World Forum for Harmonization of Vehicle Regulations

Proposal for Supplement 10 to the 05 series of amendments to Regulation No. 83 (Emissions of M₁ and N₁ vehicles)

Submitted by the Working Party on Pollution and Energy*

The text reproduced below was adopted by the Working Party on Pollution and Energy (GRPE) at its sixtieth session in order to update the specifications for the proportional speed fan which can be used during testing of the vehicle on the chassis dynamometer and to bring in the line the requirements for type VI test with those of the European Union directive 2001/100/EC. It is based on ECE/TRANS/WP.29/GRPE/2010/11 and ECE/TRANS/WP.29/GRPE/2010/12, both not amended. It is submitted to the World Forum for Harmonization of Vehicle Regulations (WP.29) and to the Administrative Committee (AC.1) for consideration (ECE/TRANS/WP.29/GRPE/60, paras. 35 and 37).

Annex 4, paragraph 6.1.3., amend to read:

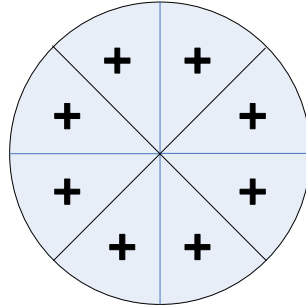
“6.1.3. A current of air of variable speed shall be blown over the vehicle. The blower speed shall be within the operating range of 10 km/h to at least 50 km/h, or as an alternative, at the request of the manufacturer, within the operating range of 10 km/h to at least the maximum speed of the test cycle being used. The linear velocity of the air at the blower outlet shall be within ±5 km/h of the corresponding roller speed within the range of 10 km/h to 50 km/h. At the range over 50 km/h, the linear velocity of the air shall be within ±10 km/h of the corresponding roller speed. At roller speeds of less than 10 km/h, air velocity may be zero.

The above mentioned air velocity shall be determined as an averaged value of a number of measuring points which

- (a) For blowers with rectangular outlets are located at the centre of each rectangle dividing the whole of the blower outlet into 9 areas (dividing both horizontal and vertical sides of the blower outlet into 3 equal parts).
- (b) For circular blower outlets, the outlet shall be divided into 8 equal arcs by vertical, horizontal and 45° lines. The measurement points lie on the radial centre line of each arc (22.5°) at a radius of two thirds of the total (as shown in the diagram below).

These measurements shall be made with no vehicle or other obstruction in front of the fan.

The device used to measure the linear velocity of the air shall be located at between 0 and 20 cm from the air outlet.

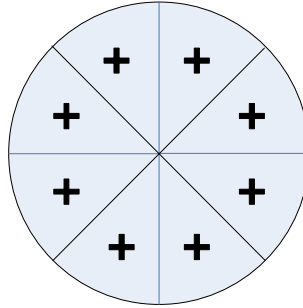
The final selection of the blower shall have the following characteristics:

- (c) Area: at least 0.2 m²;
- (d) Height of the lower edge above ground: approximately 20 cm;
- (e) Distance from the front of the vehicle: approximately 30 cm.

As an alternative, at the request of the manufacturer the blower speed shall be fixed at an air speed of at least 6 m/s (21.6 km/h).

The height and lateral position of the cooling fan can also be modified at the request of the manufacturer.”
